DRAWN	DEH
DATE	15/03/94
TITLE	LGC80/120 PREAMP
DRW. NO.	9052_3

TITLE
120 WATT OUTPUT BOARD No. 8991 PART No

DRAWN	TRACED	CHECKED	APPROVED	DATE
S.L.				30/08/94
DRAWING No.		2314

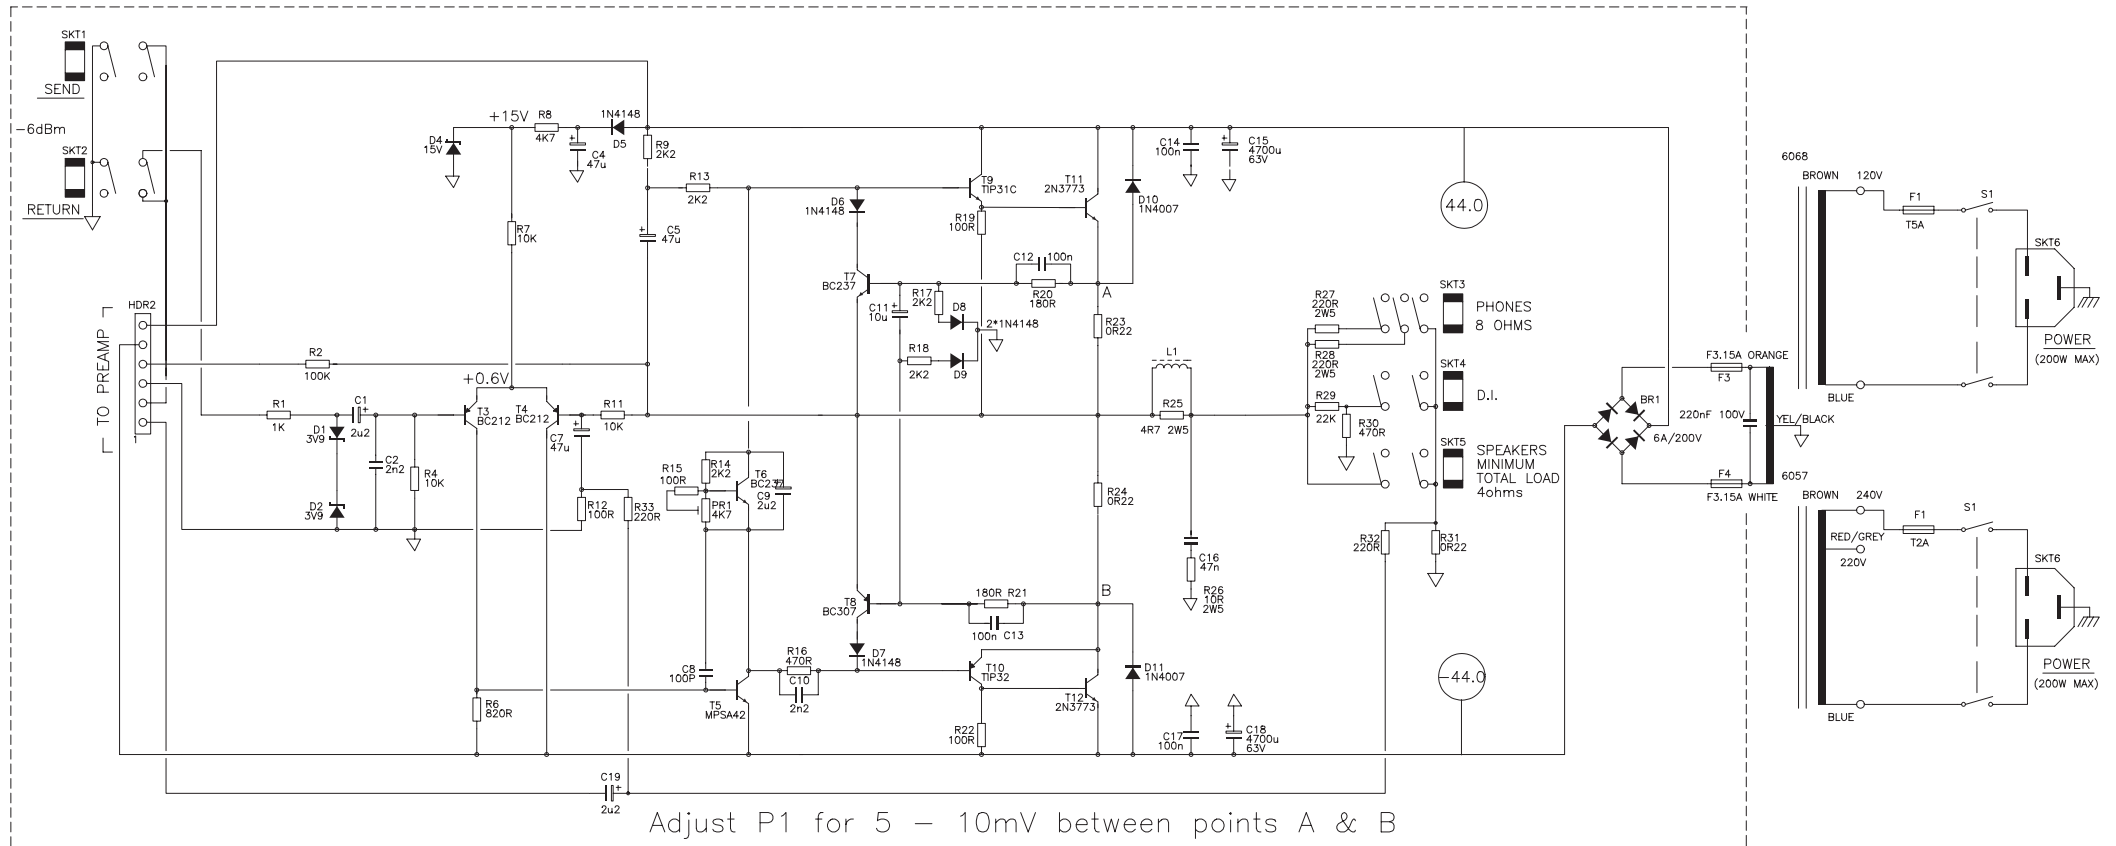
ISSUE	DESCRIPTION	APPD.	DATE
	220nF 100V Cap added across TX secondary This should be soldered directed to the underside of the pcb		11/02/99
